TENNESSEE VALLEY AUTHORITY

KINGSTON FOSSIL PLANT

ANNUAL ASH POND DIKE
STABILITY INSPECTION
2009

Prepared by: Chris Buttram
Date: January 12, 2009

Fig. 3 Discharge to Stilling Pool

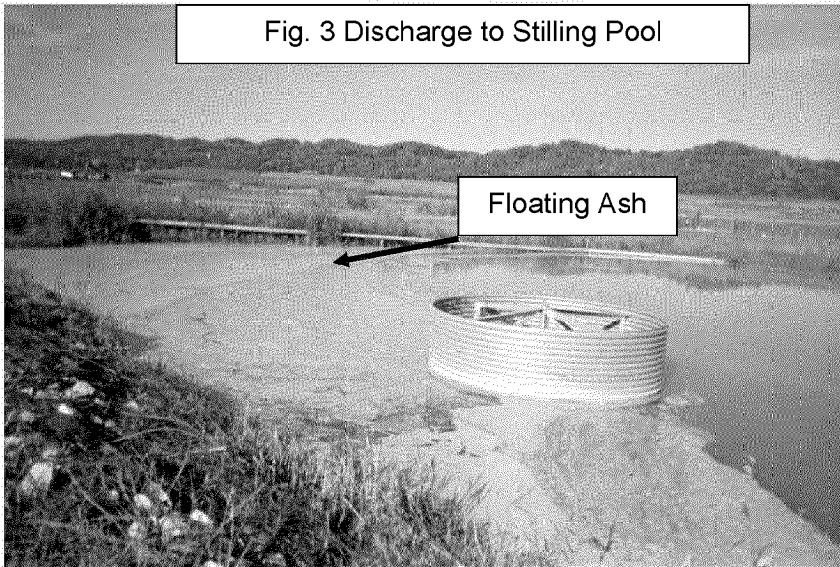
Floating ash near discharge structures, as seen in Figure 3 below, should be removed to prevent an accidental release. Check the floating skimmer booms and maintain them to keep floating ash away. The seeps on the bench of Dike "C" north of the intake skimmer, mentioned on previous reports, have not been observed since wheel ruts were repaired a few years ago. No seeps or wet spots were seen in this area during the inspection.

Fig. 4 Typical Erosion on Road

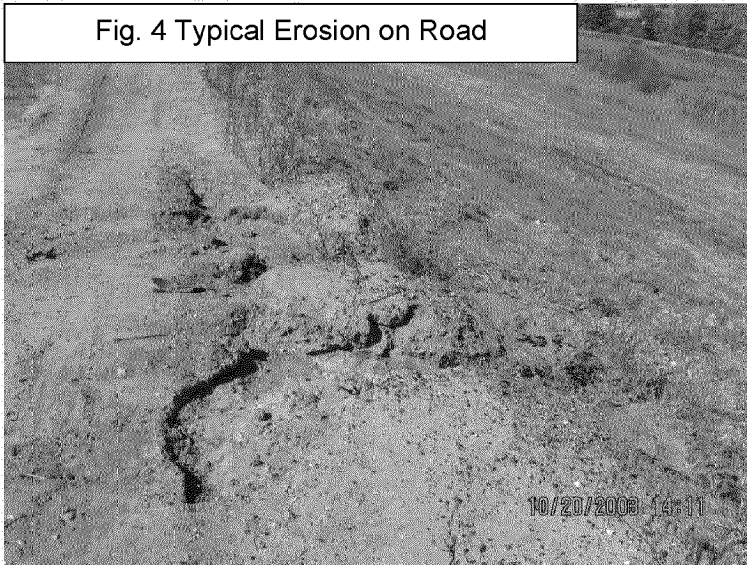
Some of the dike roads exhibit areas of erosion on the edges and some rutting, see Figure 4. This photo is typical of the eroded areas of the roads. Although it does not appear to be a significant problem, these eroded areas, as well as any ruts, should be graded out and the road covered with crushed stone to prevent larger erosion gullies.

Fig. 5 Ash Pond Internal Dike

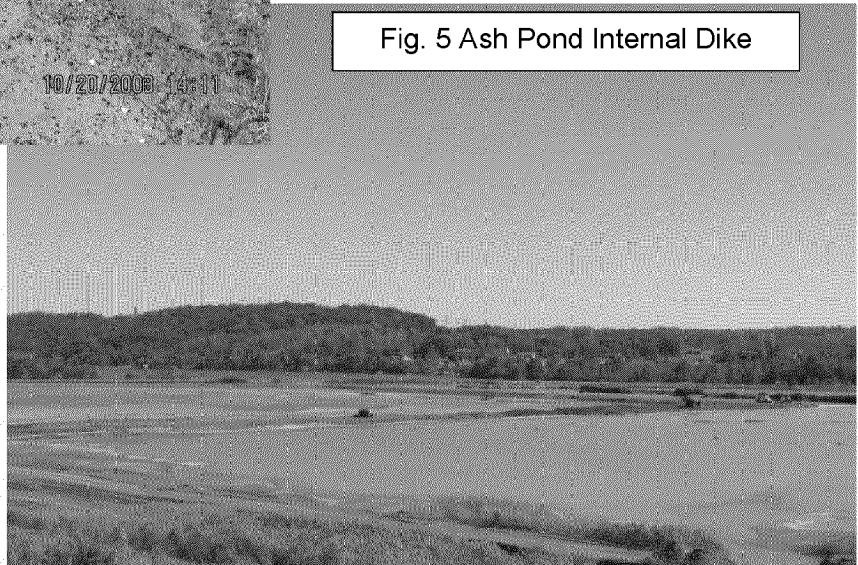
Construction of an internal divider dike inside the active ash disposal area is currently underway. The dike is one foot

to two feet above elevation 760, the elevation of the water in the pond. The divider dike will be constructed to build a base of fly ash for a dredge cell expansion, which will eventually cover approximately half of the existing main ash pond. See Figure 5.

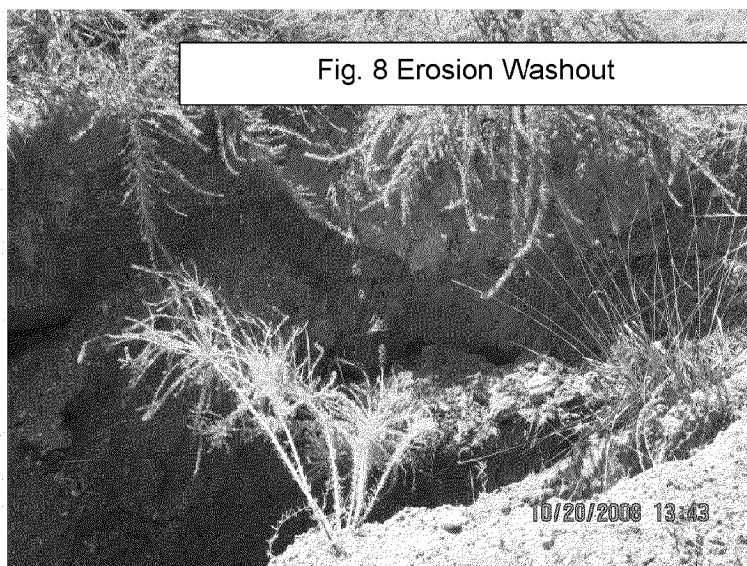
drainage should be graded so they will drain, even if slowly. Also, thick vegetation in drainage ditches (Fig. 6) should be thinned out or removed to keep from blocking the water flow. Wheel ruts on benches or in roads that are holding water should be filled with bottom ash and covered with stone.

Fig. 12 & 13 Washout on dike bench

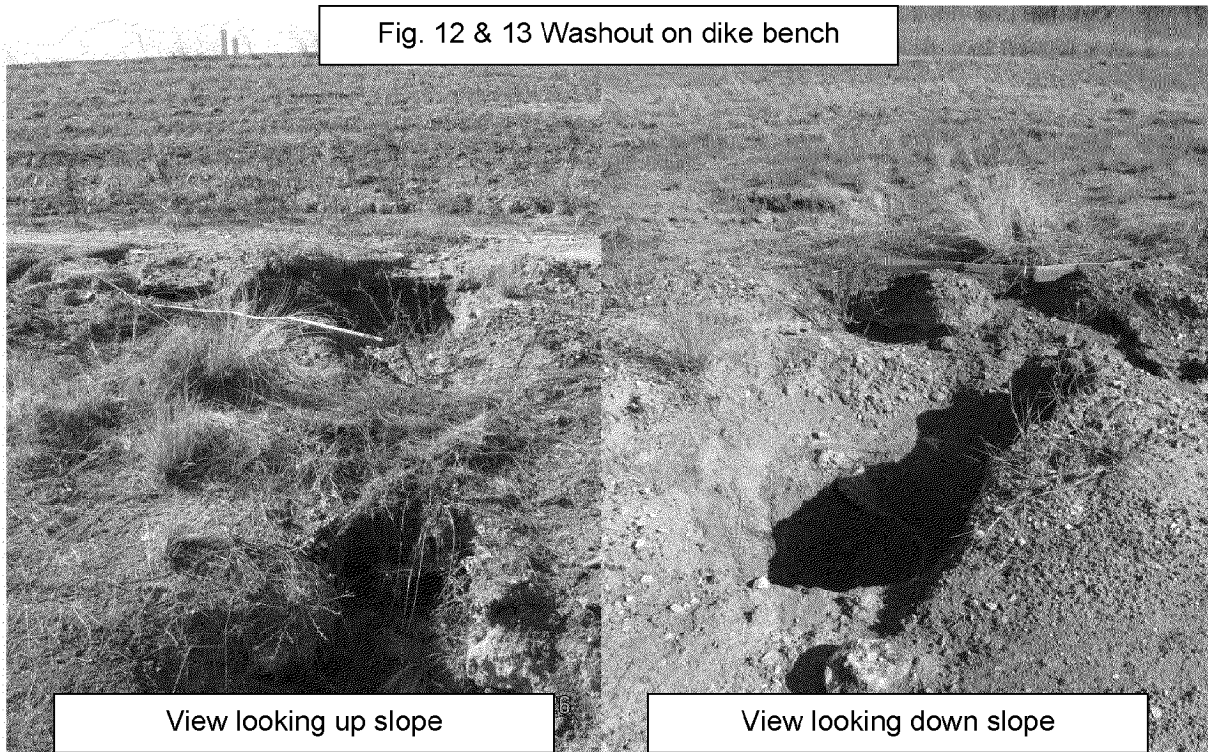
Due to extensive erosion in one area, a washout two feet wide by twenty feet long by two feet deep had formed (Fig. 8). This area should be repaired by filling bottom layer with six inch lifts of compacted bottom ash until clay area is reached. Cap with one foot of clay using six inch compacted lifts. It is recommended that an erosion control blanket be used in this area for quicker vegetation growth. Monitor this area, especially after rain events, to assure that no settling occurs.

Plant operations has mowed the dredge cell slopes. Small trees growing on the slopes have been cut level with the ground. If trees are too large to be mowed, the trees should be cut, the stumps removed, and the area backfilled with soil, compacted and seeded and fertilized. Several areas around the dikes of the dredge cells are in need of seeding and fertilizing. It is recommended these areas should be reseeded and fertilized per T-1, section 580. At the north end of the dredge cells, one of the lower dike benches has an area that has eroded and washed out (See Figures 12 and 13 below). This area should be repaired by filling with clay in 6" lifts and compacting. After the area has been filled and compacted, reseed and fertilize per T-1, section 580. A small wet spot was noticed at

- Repair broken dewatering well outlet pipes. These pipes should be draining directly into the lined ditch at the bottom of the cells.
- Repair the 2' x 20' area of erosion on the east slope of the interim dredge cell. Fill bottom layer with bottom ash in 6" lifts and compact. When the clay layer is reached, cap with 1' of clay via 6" compacted lifts. Lastly, cover with an erosion control blanket to help stabilize the damaged area. After repairs have been made, continue to monitor area until good vegetation has stabilized the area.
- Repair erosion washout on lower dike bench at North end of dredge cells. Repair eroded area by filling with clay in 6" lifts and compacting, then reseed and fertilize per T-1, section 580.
- Continue to monitor the wet spot at the toe of the Cell 2 dike.

Fig. 16 Check Dams needing repair

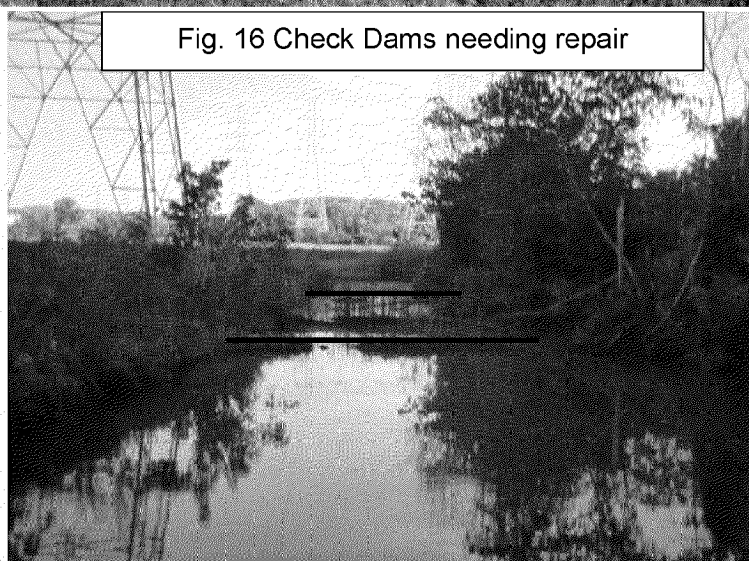
contain coal yard sediment. Figure 16 shows rock check dams built to keep the coal fines away from the pumps. The check dams appear to be in need of repair and cleaning out. If maintained properly, the check dams will keep sediment from reaching the pumps. TVA drawing 10W225-1 (attached as API 2009-2) shows the pond and its intended bottom contours. The coal yard drainage basin should be cleaned out annually.

- Dredge the coal yard drainage basin to restore its design contours and protect the pumps from further damage. There is an estimated 2,800 cubic yards of sediment in the original pond and an extra 3,400 cubic yards in the "V" section that needs to be removed as soon as reasonable. See the attached copy of 10W225-2.
- Repair and clean out riprap check dams in the coal yard drainage basin to keep solids away from the pumps.

Fig. 23 Dewatering well overflowing redwater

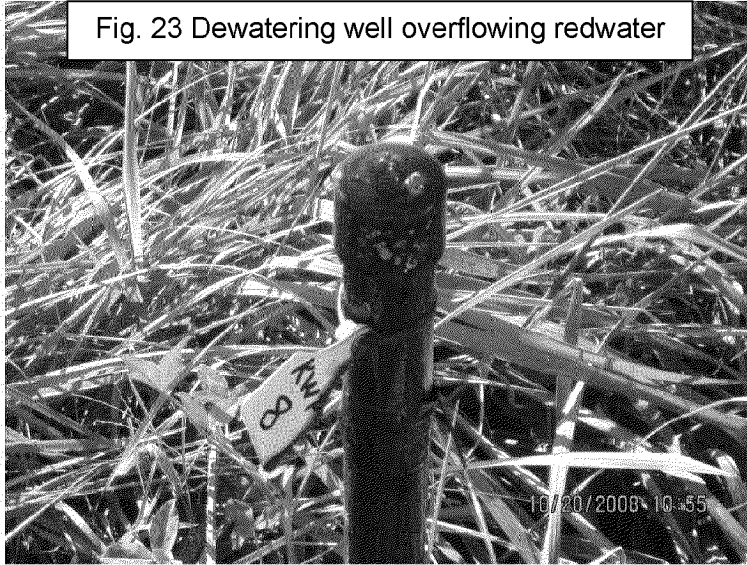
Besides the wetlands, there was only one spot that showed flowing redwater. When dissolved iron from the ash and water mix, it tends to give the water a red appearance. This area was first thought to be a seep, but it was discovered that the redwater was flowing out of a dewatering well that had a closed valve. The water was flowing down the slope into the riprap ditch. The riprap ditch was also stained some at the outlet area for this dewatering well.
